Re: Sri Venkateswara Temple and Cultural Center  
Woodland Review of the 3<sup>rd</sup> Revised Preliminary Site Plan (SP#08-08C)

**PLAN REVIEW CENTER REPORT**  
February 17, 2009  
**Revised Preliminary Landscape Review**  
Sri Venkateswara Temple SP#08-08C

**Re: Sri Venkateswara Temple – Preliminary – 3<sup>rd</sup> Revision**  
SP No. 08-08C  
OHM Job No. 163-07-0562

Sri Venkateswara Temple  
SP #08-08C

Above: Forested vernal pool welland originally not shown on plans, now referred to as Wetland H  
Below: Mature bitternut hickory where southwestern parking lot is proposed

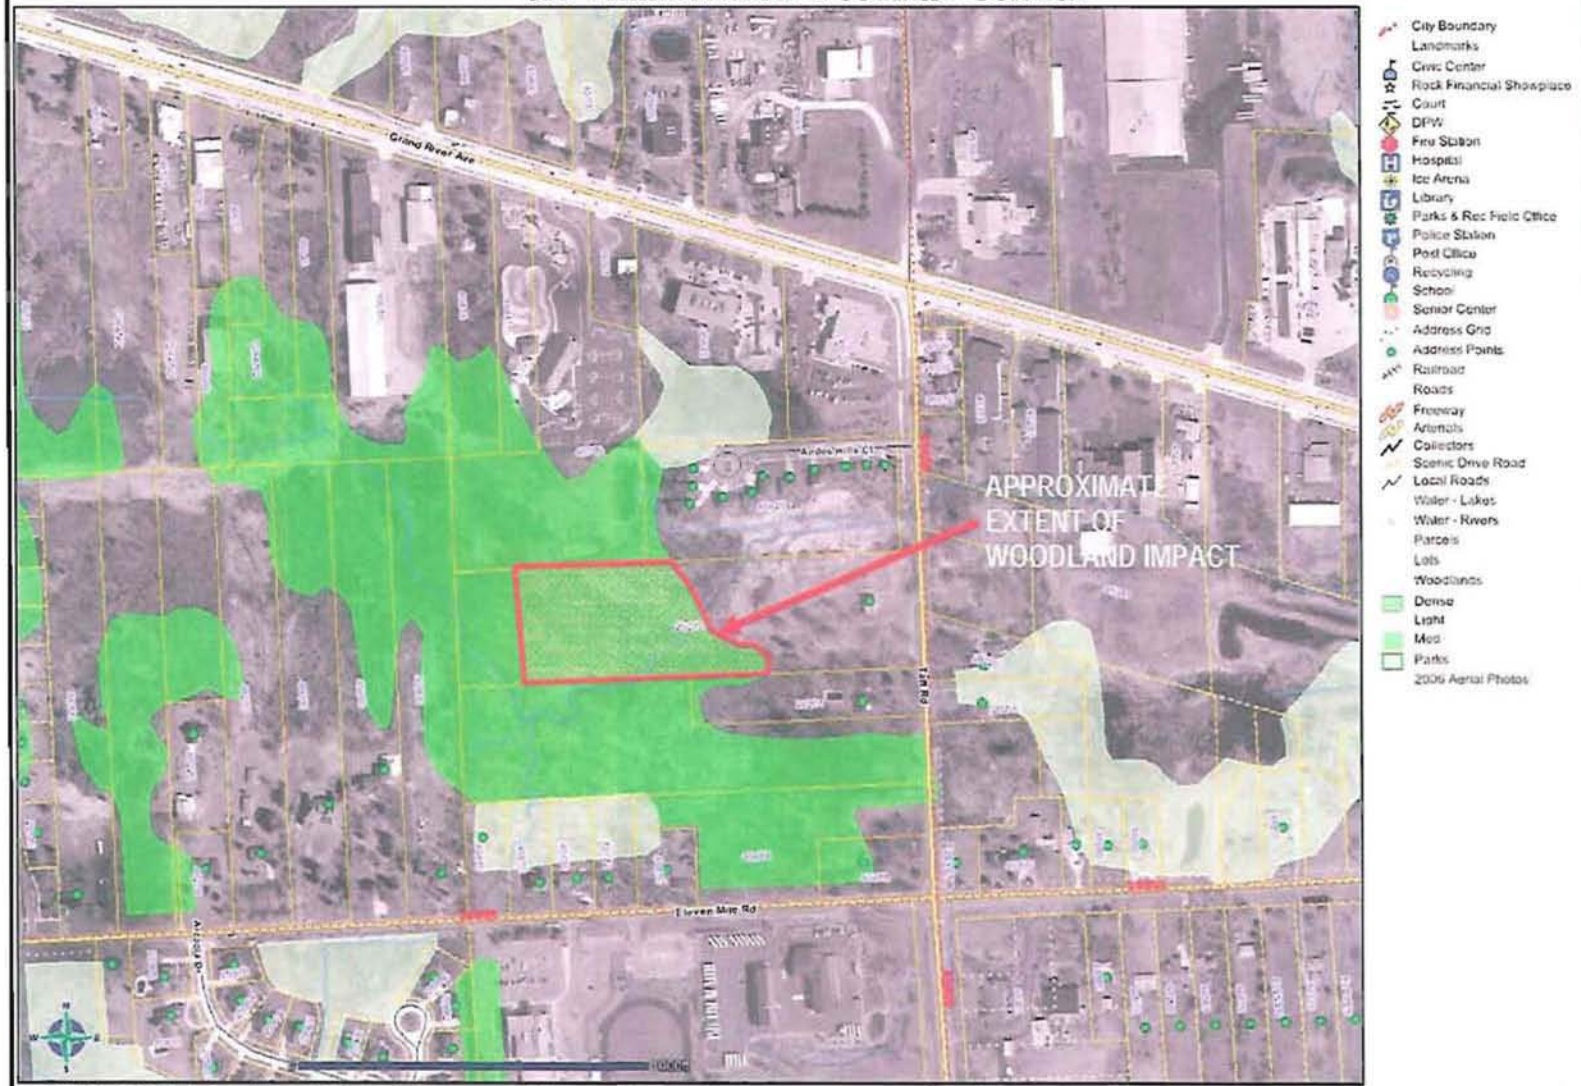
ECT has reviewed the City of Novi Official Woodlands Map and completed an onsite Woodland Evaluation on Wednesday, March 26, 2008. With the exception of an unflagged forested vernal pool area in the northwest portion of the regulated woodland, ECT found that the *Tree Survey/Tree Removal Plan* (Sheet 3) accurately depicts existing site conditions. The surveyed trees have been marked with the survey numbers in yellow paint. Numerous mature hardwood trees exceeding 20 inches in dbh occur scattered throughout the regulated woodland where the temple and associated parking (Phase 1) are proposed, including sugar maple (*Acer saccharum*), red maple (*Acer rubrum*), red elm (*Ulmus rubra*), black walnut (*Juglans nigra*), bitternut hickory (*Carya cordiformis*), and tuliptree (*Liriodendron tulipifera*). The site showed evidence of disturbance, with soil spoil piles, brush heaps, and debris piles located near the transition between old field and regulated woodland and mature black locusts (*Robinia pseudoacacia*) scattered throughout the regulated woodland. See attached site photographs.

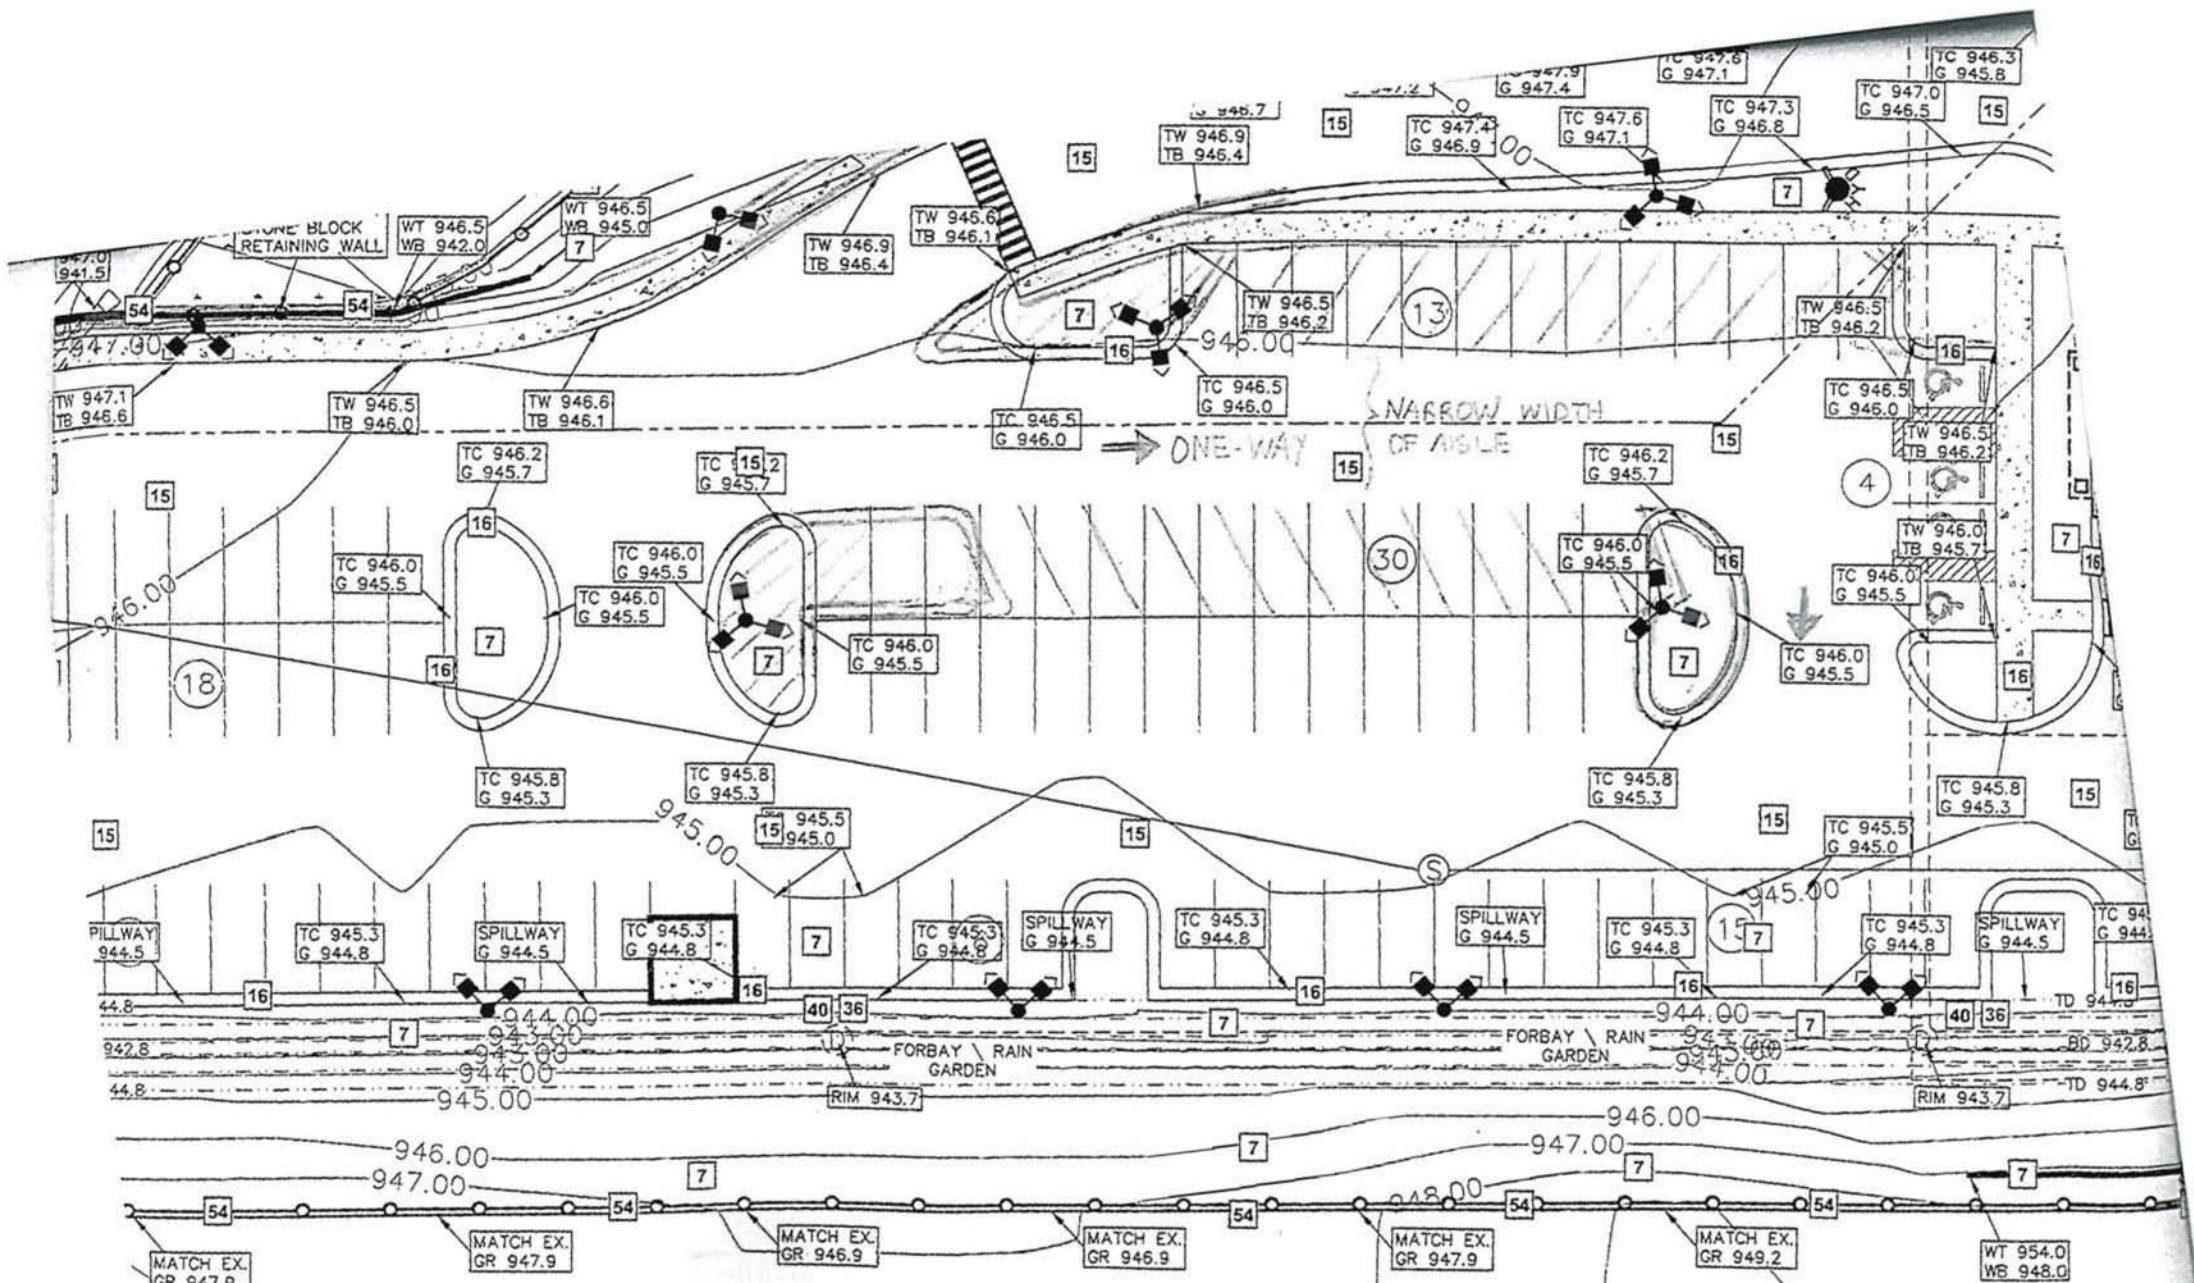
1. Parking Lot Entry Points: The current configuration of the main drive aisle and the westerly entrances into the Cultural Center parking lot intersect to form a rather wide intersection, with one leg at a significant skew. The intersection geometry, coupled with the nearby pedestrian crossing, pose several safety concerns that could be eliminated by reconfiguring this area.

The east/west row of 90-degree parking should be converted to angle parking, thereby making it one-way. We also recommend minor geometric changes at this location, in order to minimize the likelihood of entering vehicles making a left turn from the main drive aisle into this lot. Please see attached sketch.

The sketch shows the elimination of a handful of parking spaces at the west end of the one-way aisle, so that vehicles exiting their parking space will not back into the main drive aisle on a radius section. We recognize that parking is limited on-site, and that this may result in a net loss. If possible, we suggest adding a bank of parking stalls along the north edge of the site,
